FPR Example Comments

Historic Resource-related Comment

..... BLA ELA & R/W AREA	 DISTRICT 1	 SCALE IN FEET	REVISION DATES		CONSTRUCTION PLAN SR 60 BRIDGE REPLACEMENT AT SUCHES CREEK	
			CHECKED: DRAWN/REVISION: CORRECTED: REVISION:	DATE: DATE: DATE: DATE:	DRAWING No. 13-0003

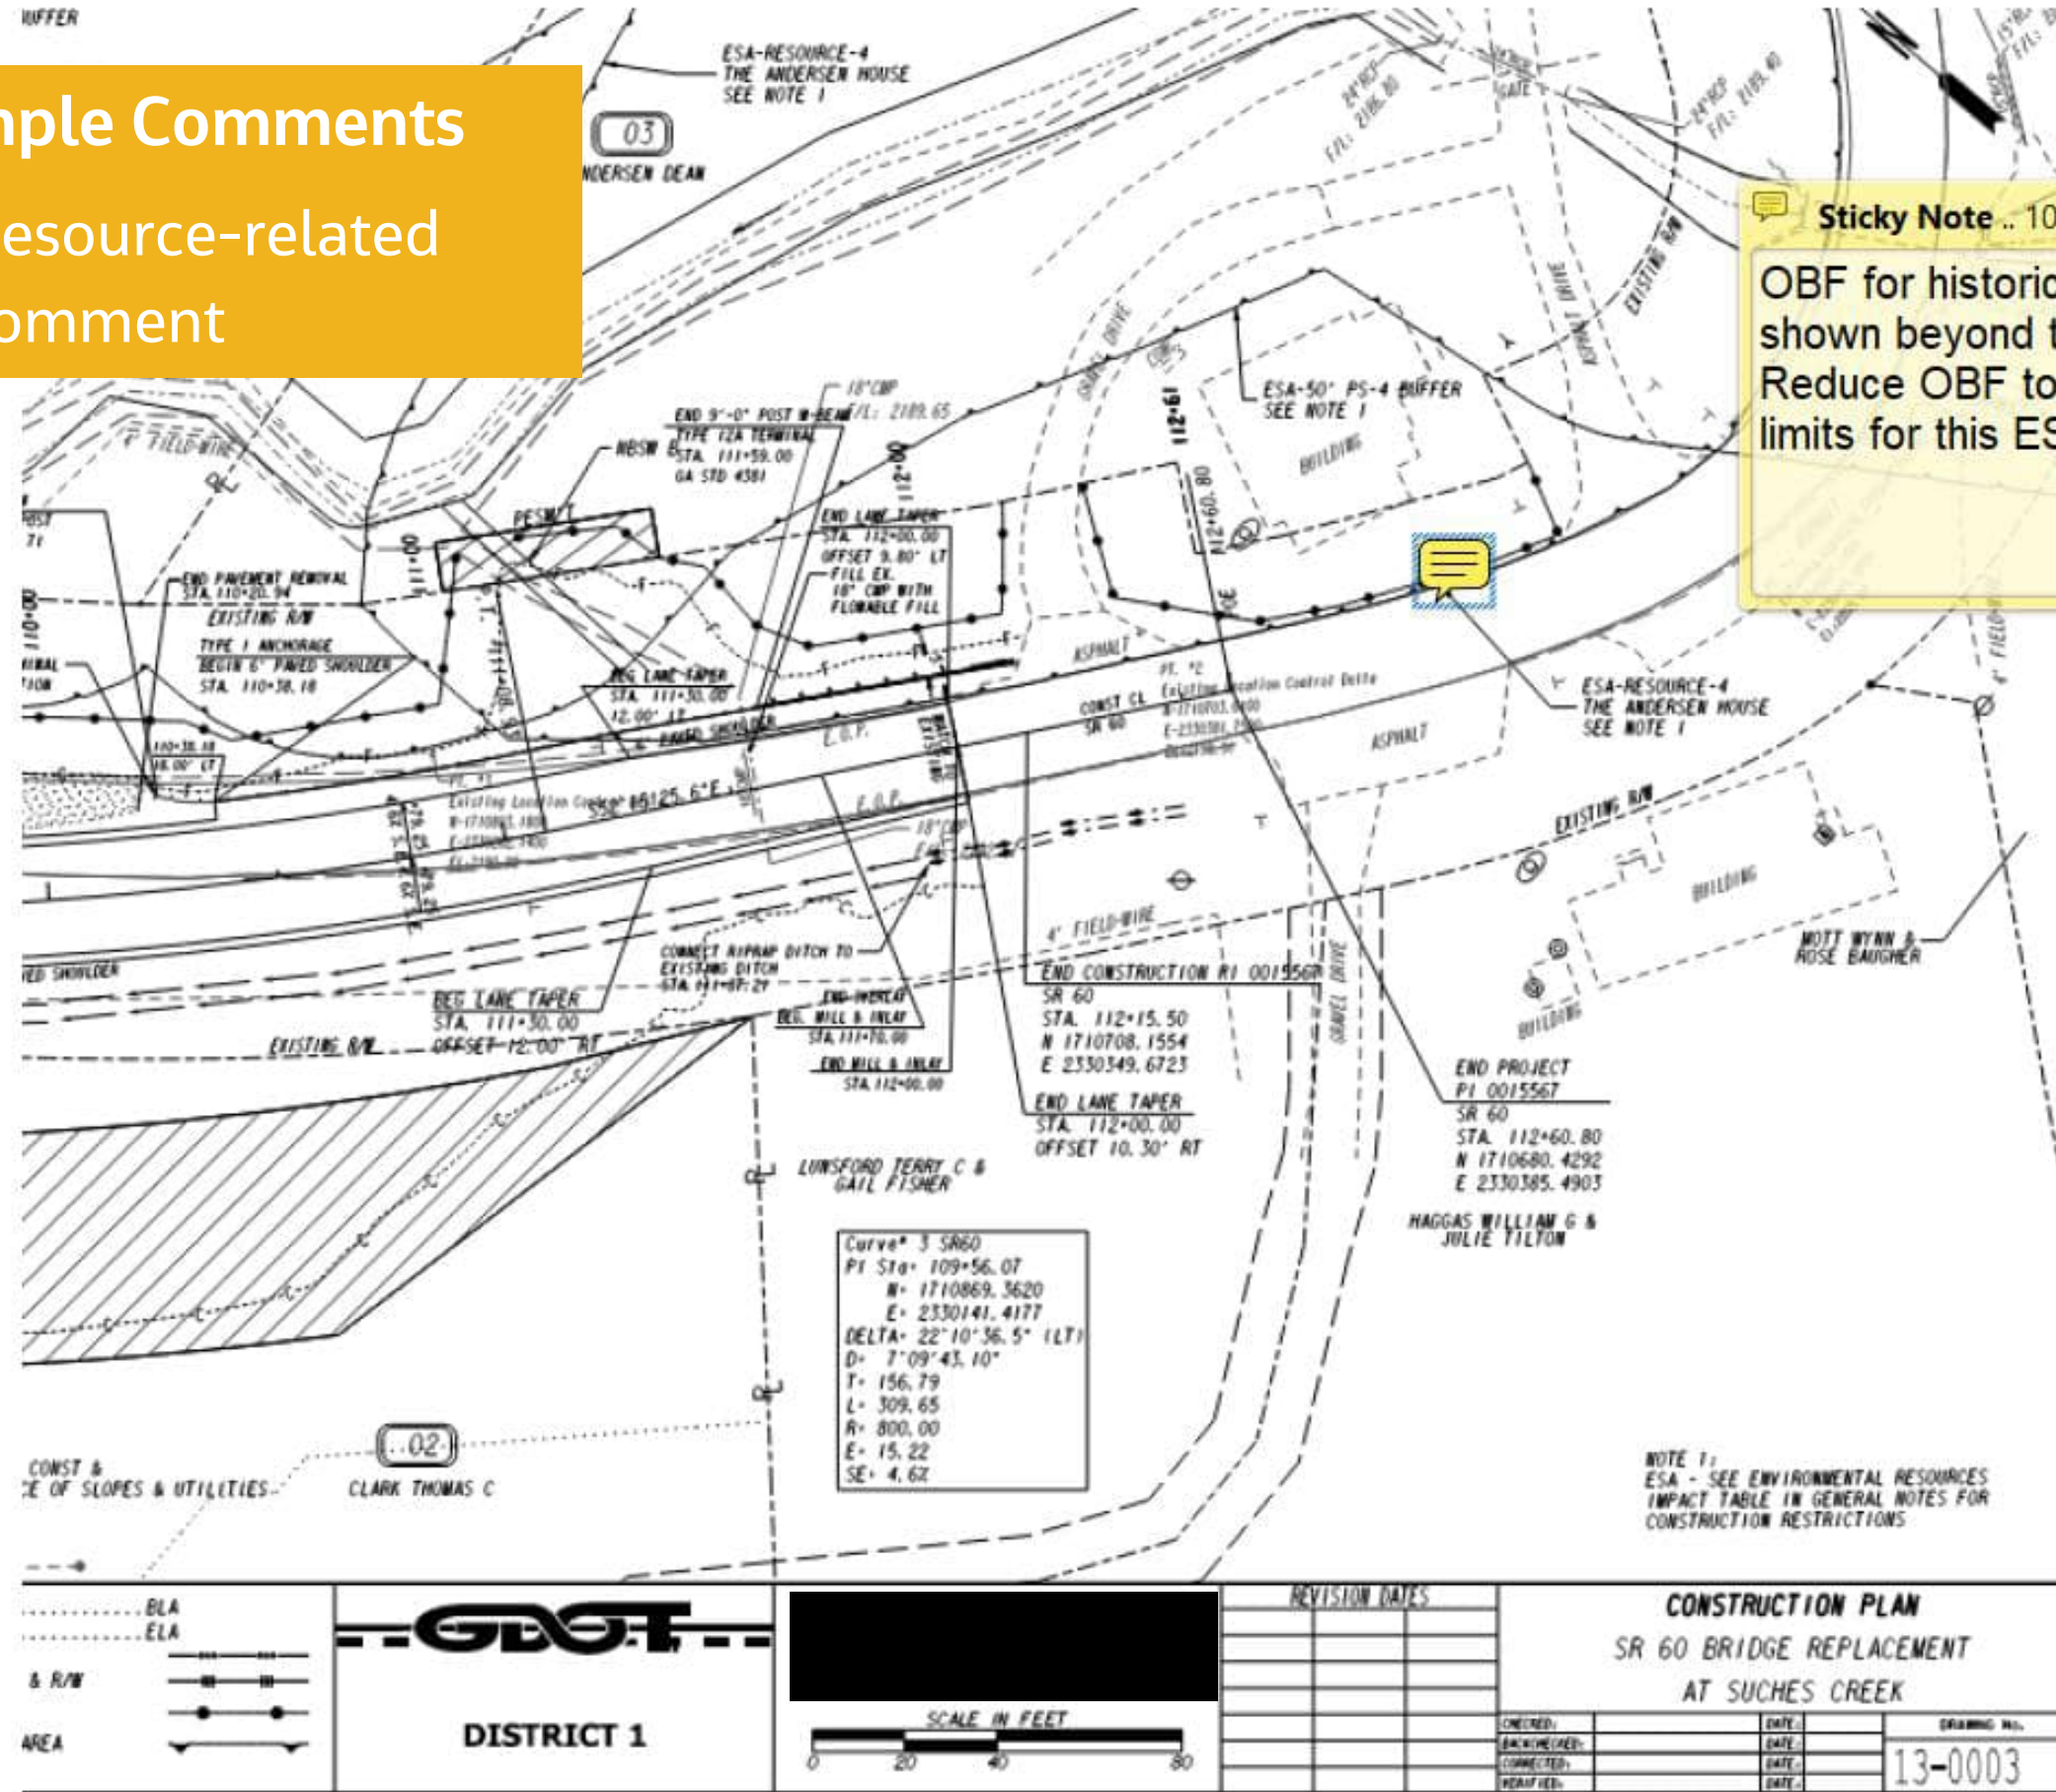
OBF for historic resource ESA is shown beyond the project limits. Reduce OBF to be within project limits for this ESA.

REVISION DATES		CONSTRUCTION PLAN	
CHECKED:	DATE:	SR 29 BU/US 441 BU @ FISHING CREEK FROM STA 110+50 TO 116+00	
DESIGNED:	DATE:	DRAWING No. 13-0003	
CONSTRUCTED:	DATE:		
VERIFIED:	DATE:

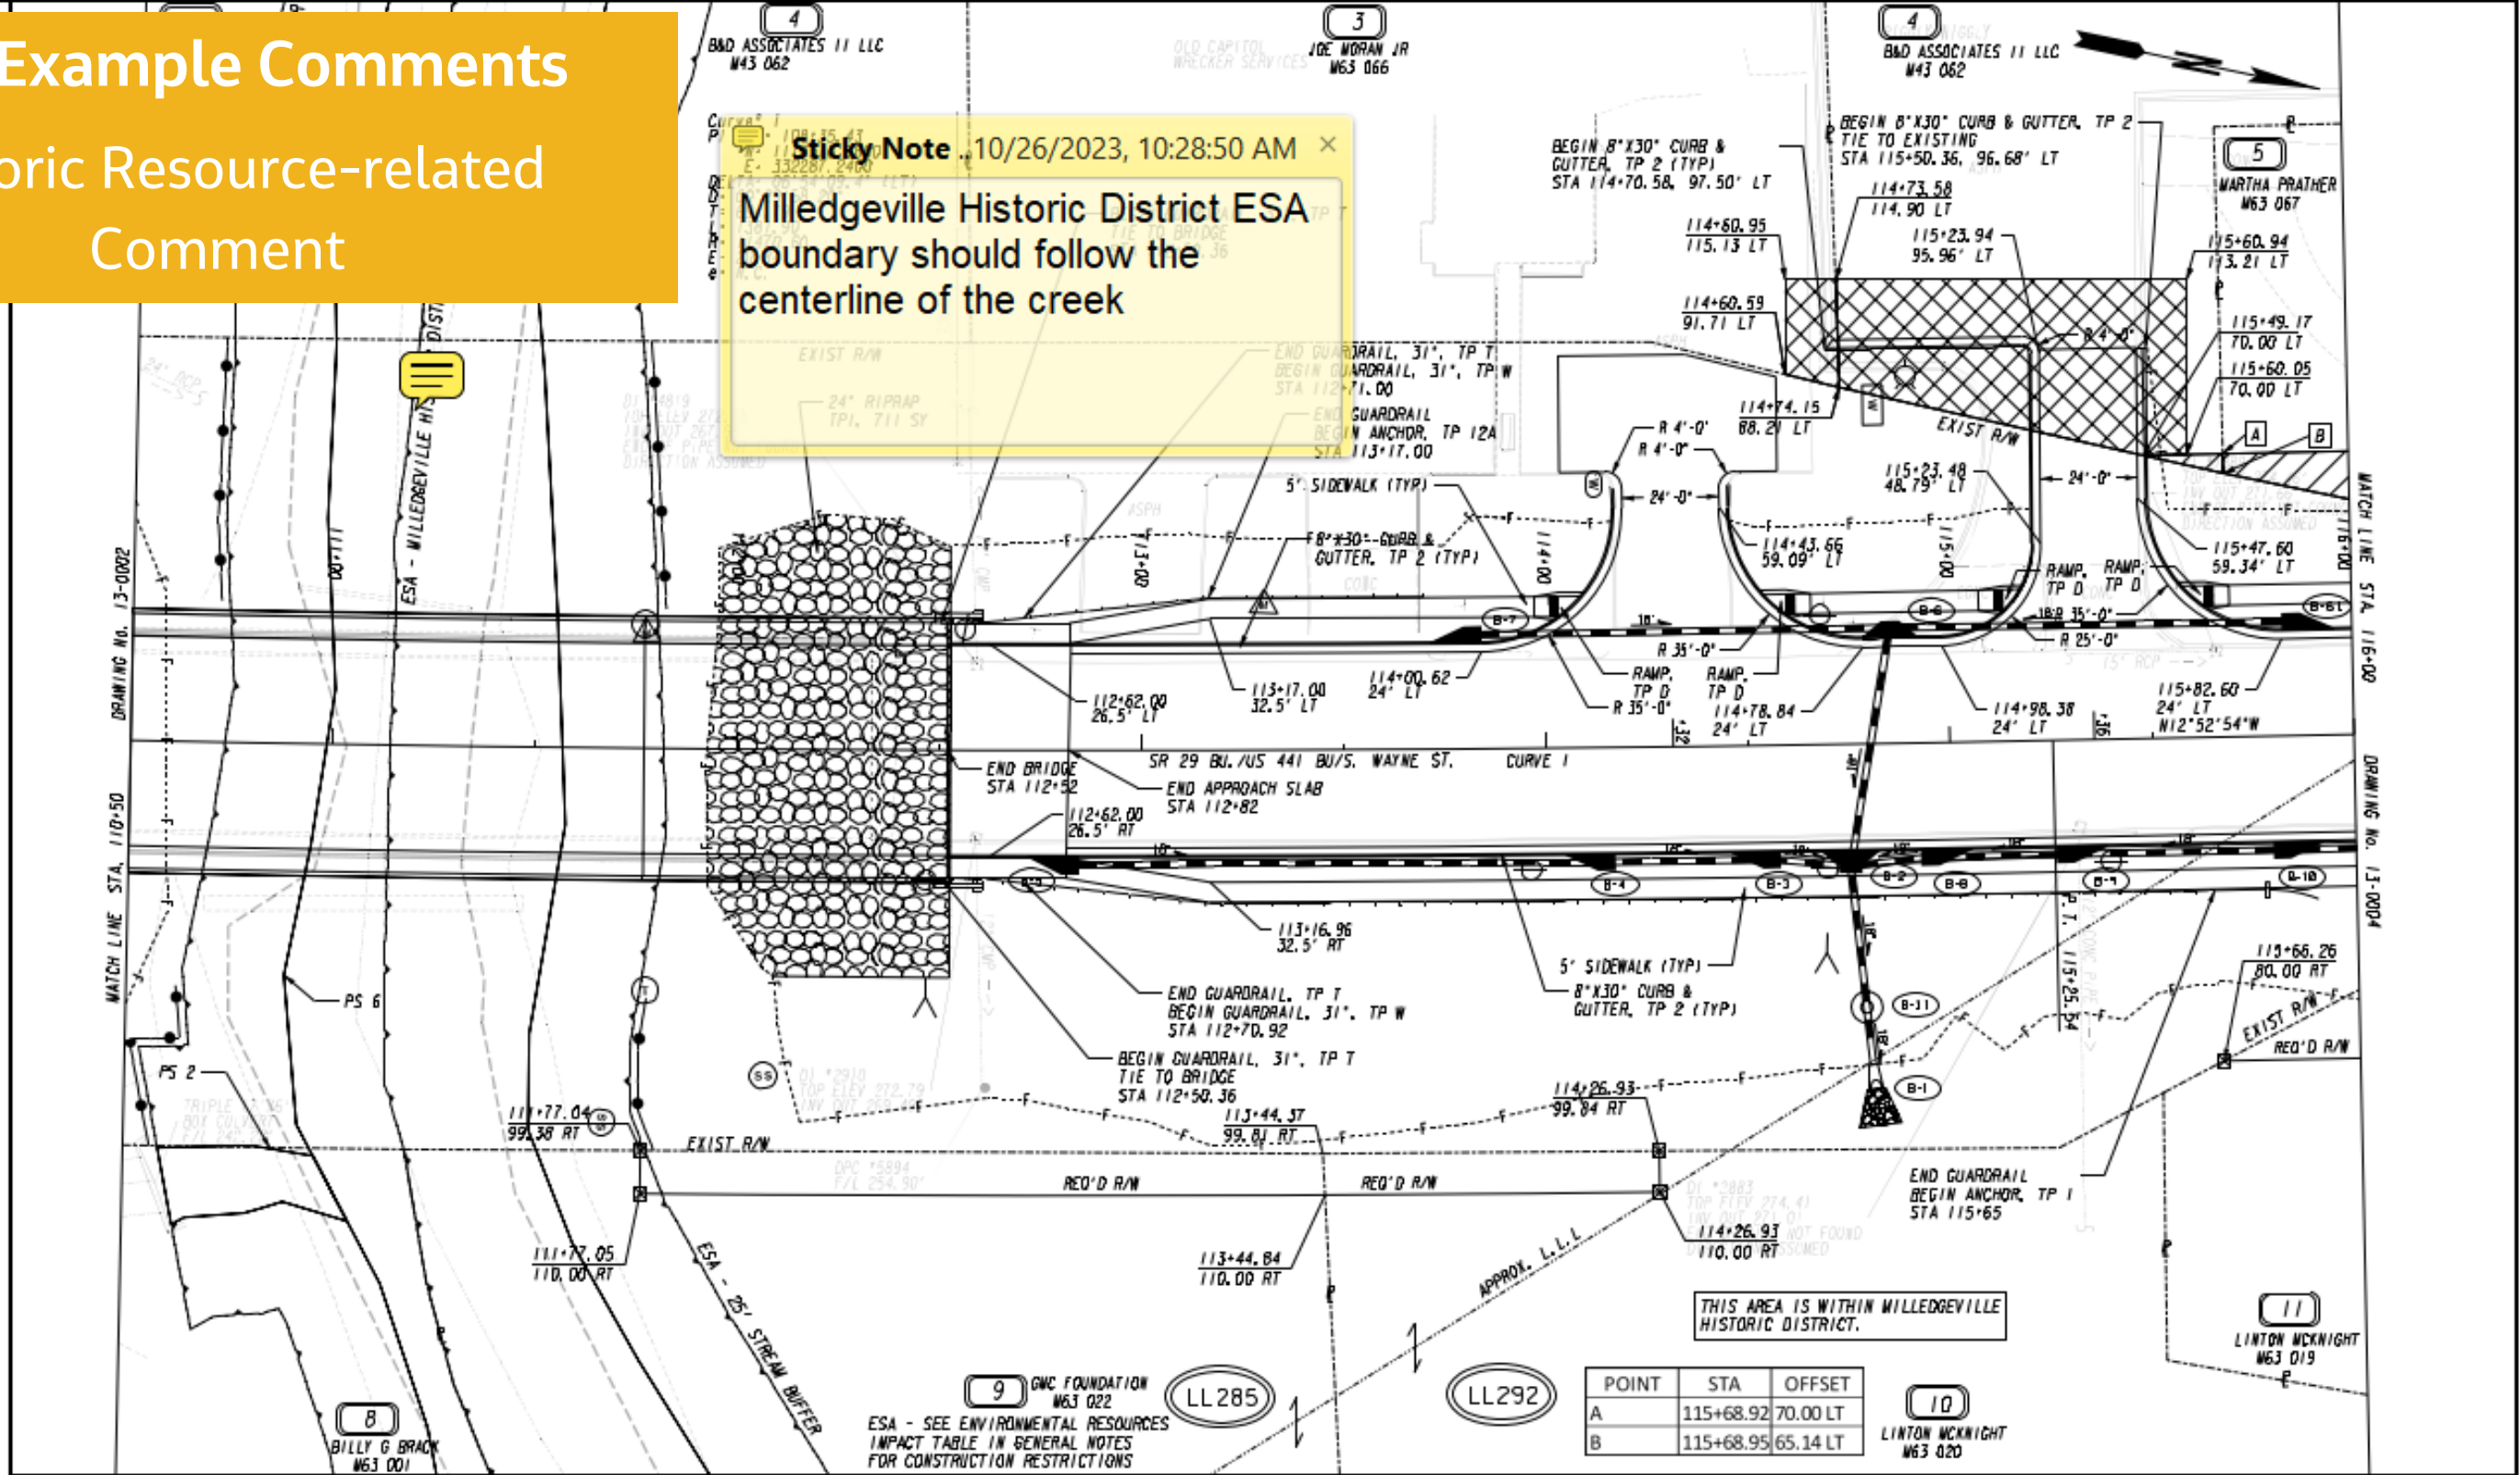
Milledgeville Historic District ESA boundary should follow the centerline of the creek

NOISE BARRIER PLANS ROCK QUARRY ROAD		CHECKED:	DATE:	DRAWING No.
		BACKCHECKED:	DATE:	34-0001
CONNECTED:	DATE:			
VERIFIED:	DATE:

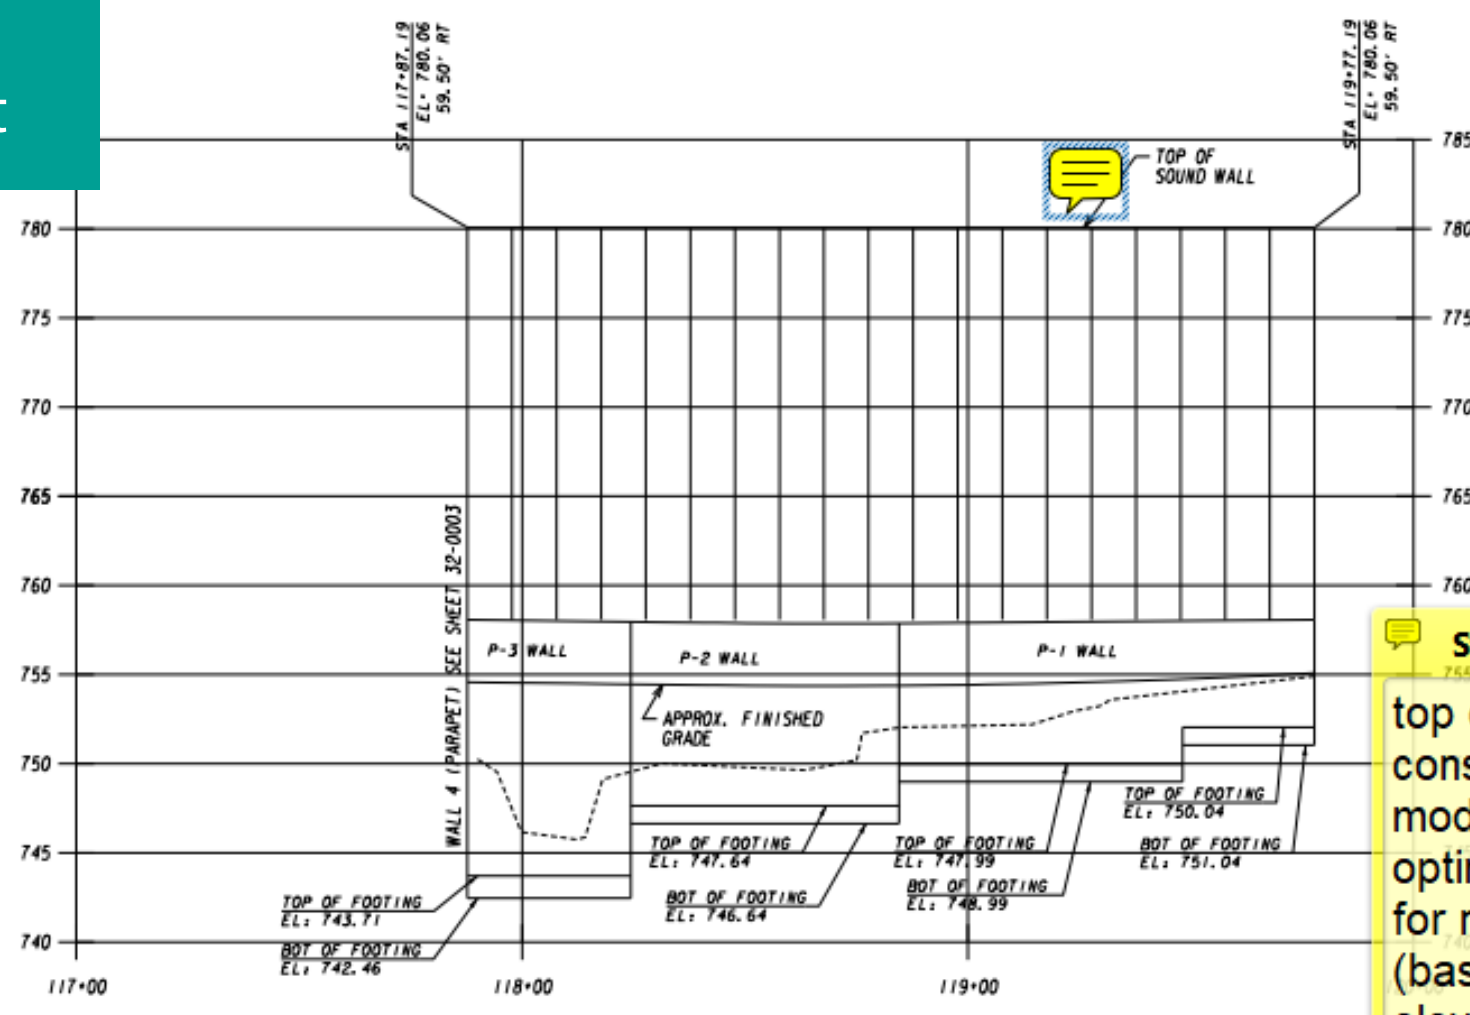
Sticky N.. 6/19/2023, 2:52:02 ..
 top of wall heights are not consistent with the noise models. Please see barrier optimization spreadsheet for noise barrier dimensions (base and top of wall elevations).

The plans need to be revised to include the correct barrier heights. Also, the engineers shifted the barriers due to design constraints so the coordinates changed, but only the noise models needed to be updated with those. The coordinates in the plans are good. Coordinating with the engineers to ensure consistency between the noise models and the plans.
